**SITE PLAN REVIEW COMMITTEE
MEETING AGENDA**

Market Common Phase II (SP #339)

SPRC AGENDA: 1st Meeting – July 13, 2017

Wilson Boulevard – view looking southwest

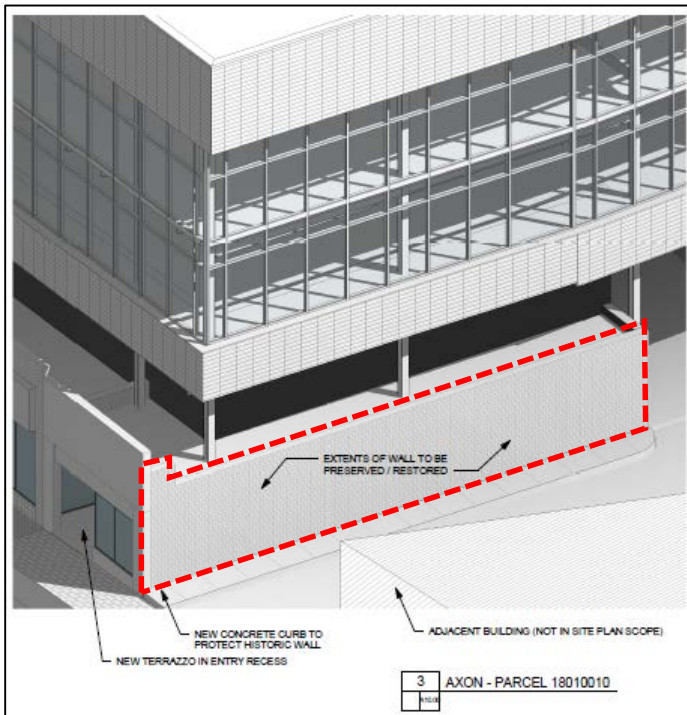
Streetscape Width on Wilson Boulevard

The sidewalk along Wilson Boulevard is not consistent with the Sector Plan, nor does it meet minimum County guidelines for no less than six feet of pedestrian clear width. At the narrowest point, clear width between the building wall and the tree planter box is as little as 2.5 feet. This condition existed prior to approval of site plan #339, which incorporated the Sears Department Store building footprint that limits the potential sidewalk width on this block. Design options should be explored to improve this condition.
